MONTGOMERY COUNTY HISTORIC PRESERVATION COMMISSION
STAFF REPORT

Address:	22 Hesketh St., Chevy Chase	Meeting Date:	09/06/17
Resource:	Contributing Resource Chevy Chase Village Historic District	Report Date:	09/30/17
Applicant:	Maggie & Robert Marcus	Public Notice:	08/23/17
Review:	HAWP	Tax Credit:	N/A
Case Number:	35/13-17DD	Staff:	Dan Bruechert
Proposal:	Additional construction and alterations to the detached garage

1 Second Floor Plan - Proposed
 1/8" = 1'-0"

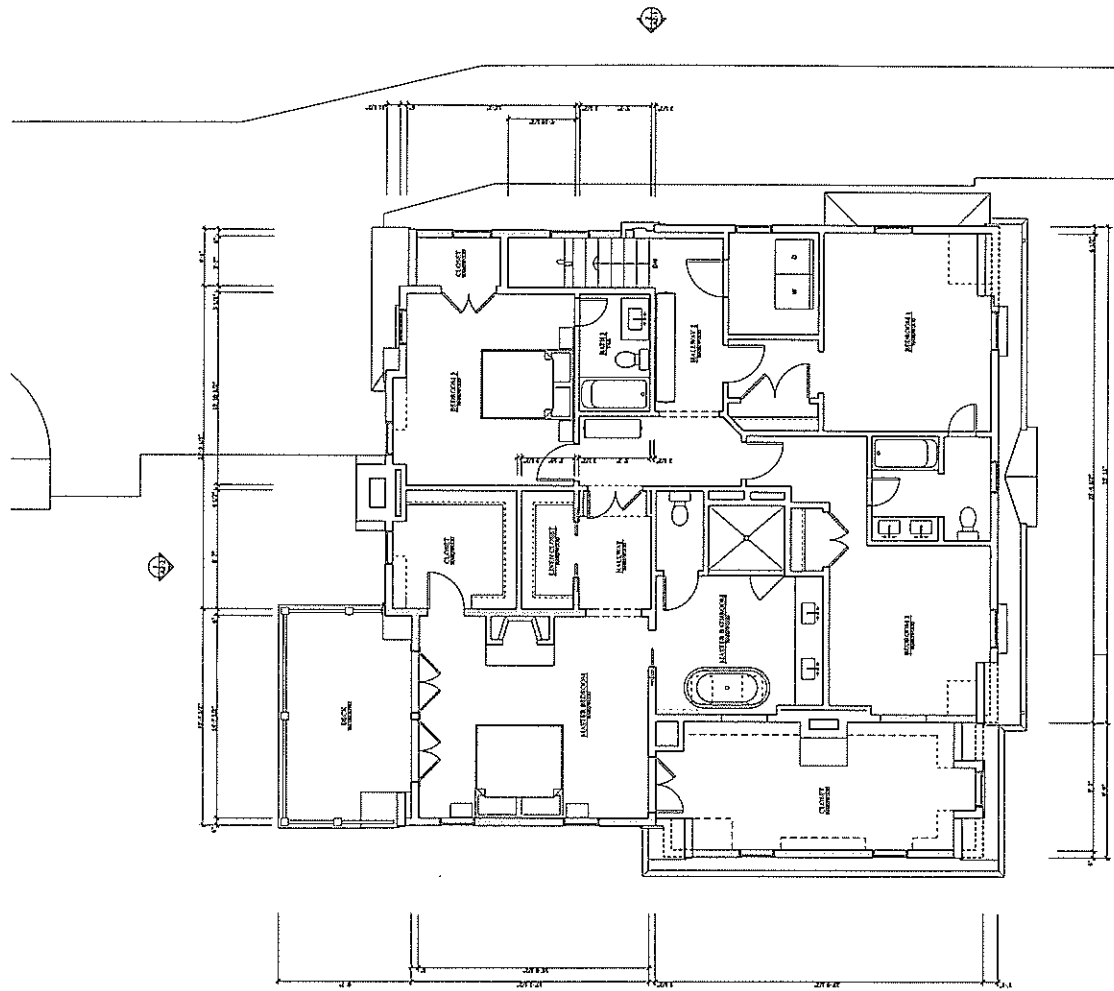
To the left of the main historic house massing is a one-story sun-porch with a wood railing enclosing the roof deck above. The applicant proposes to construct a one-room addition above the existing sun-porch. The addition will have a gambrel roof matching the slope of the historic roof and dormer, but the roof will be inset by approximately 2' (two feet). Consequently, the dormer in the addition will also be approximately 2' (two feet) lower than the dormers in the historic house. The roof and dormer will use salvaged slate to match the appearance of the roof. To further differentiate the new construction from the historic, the applicant will clad the addition in wood siding in a 4" (four inch) reveal which is one-half of the 8" (eight inch) reveal in the historic massing. The windows on the front and side of the new addition will match the windows in throughout the historic house. The windows in the historic house were all replaced in 2012.

The *Design Guidelines* dictate that second story additions that do not exceed the footprint of the historic house, as is the case here, should be given moderate scrutiny. For this level of scrutiny proposed changes should be evaluated by considering scale and massing in addition to evaluating the impact on the integrity of the historic house.

This proposed change will obviously have an impact on massing of the house by constructing an addition at the front elevation. Staff recognizes that this is not the preferred location to construct an expansion, but believes there are several mitigating factors that may make this proposal approvable. First, Staff wants to recognize that the integrity of the historic house will be largely retained by this proposal. The framing of the historic house will remain and the inset of the roofline and the change in cladding reveal will allow the new construction to read as something

new while creating a cohesive design with the historic massing. Second, because of the rise in the slope of the lot and the 27' (twenty-seven foot) setback, this construction is far enough removed from the public right-of-way that it will not overwhelm this historic house or houses in the surrounding district. Third, the *Design Guidelines* acknowledge that a grander scale of construction than what is found elsewhere in the county may be appropriate in Chevy Chase and that the evaluation of second or third story expansions should be undertaken, "in view of the predominance of large scale houses in the Village." Lastly, Staff also feels that the applicants use of high-quality, compatible materials (i.e. natural slate roofing and wood clapboard siding) are in keeping with the *Guidelines* stated policy of architectural excellence.

1 Rear Elevation - Proposed
1/4" = 1'-0"

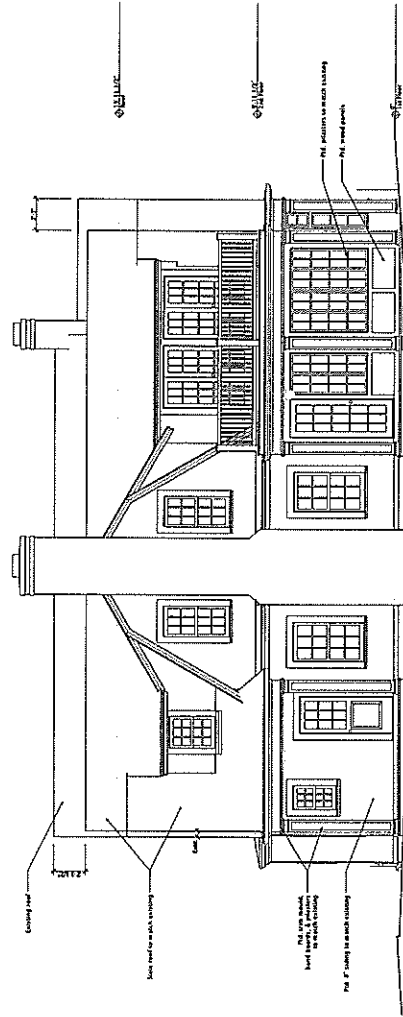
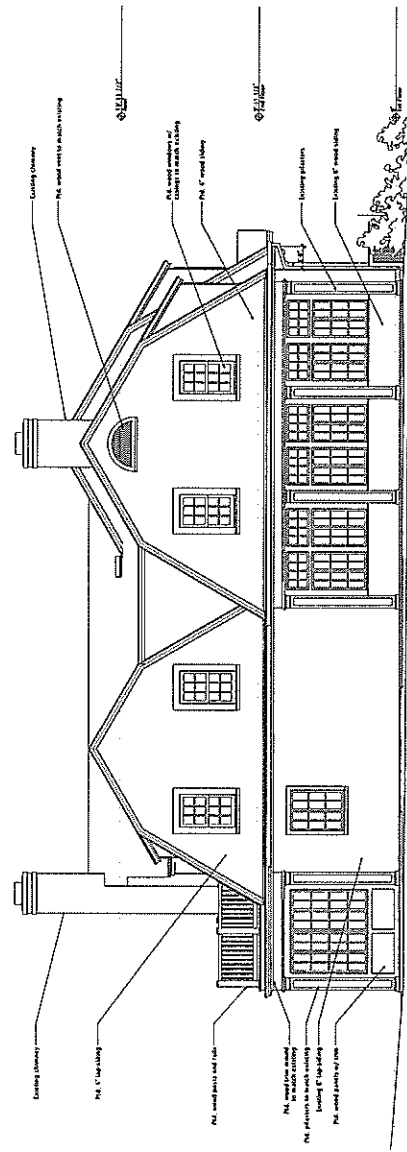
The applicants are proposing to construct a two-story addition that will measure approximately 27' 7" by 16' 4" (twenty-seven, feet seven inches by sixteen feet, four inches). The design of the new construction will match that proposed for the second story expansion at the front; a side gambrel roof, clapboard siding in a 4" (four inch) reveal, a slate roofing to match the historic, with six-over-six sash windows. The roof ridgeline will match the height of the second story expansion at the front, which is approximately 2' (two feet) lower than the historic gambrel roof ridge. The proposed rear addition will be inset 2' 3" (two feet, three inches) from the wall place of the sun porch and the proposed second floor expansion.

The appropriateness of this proposal is largely dependent on the evaluation of the second floor expansion. Because the rear proposal will be almost totally obscured by the second floor expansion, if the HPC determines that the second floor expansion is acceptable, then the proposed rear construction should be reviewed under lenient scrutiny, as it would have a minimal visual impact on the surrounding district. The photo shown on Circle 14 shows the only view where the rear addition would be visible. The side of the rear addition would have three six-over-six windows with a sun porch at the rear. The rear of the proposed addition would consist of a ground floor sun porch with a deck above. The deck will be accessed through a series of French Doors. The changes to the rear of the addition will not be visible from the public right-of-way and are to be given a "very lenient review" per the *Design Guidelines*.

While this addition is significant, Staff feels that this the design and details are in keeping with the historic house and that it will only have a minimal impact on the surrounding historic district. Staff initially questioned the applicant about the size of the new construction and what the total impact would be on the coverage of the lot. The current lot coverage of the historic house and the garage is approximately 29% (twenty-nine percent). After construction of the proposed addition the lot coverage will increase to 34.69% (thirty-four point six-nine percent), which is less than the maximum 35% (thirty-five percent) allowed in Chevy Chase. The *Design Guidelines* state that lot coverage is to be reviewed under strict scrutiny. Staff believes that, while the increase in lot coverage is significant, by massing the addition in its proposed location open space was retained to the greatest extent possible. Additionally, the addition in this location will have no impact on any trees on site and will largely retain the open, park-like setting identified in the *Design Guidelines*.

shed roof with a small deck and overhang. The applicant is proposing to reconfigure the roof to mirror the gambrel on the rear addition, to add a second story window at the rear of the right elevation, and to create a new porch at the ground floor. The other architectural details will match the proposed construction (i.e. 4" (four inch) reveal on the clapboard siding, slate roofing, six-over-six windows).

The alteration to this non-historic portion of the house will only be minimally visible from the public right-of-way and will not alter the massing or scale of the house. The architectural detailing proposed will create a more cohesive appearance and Staff supports approval of this work.
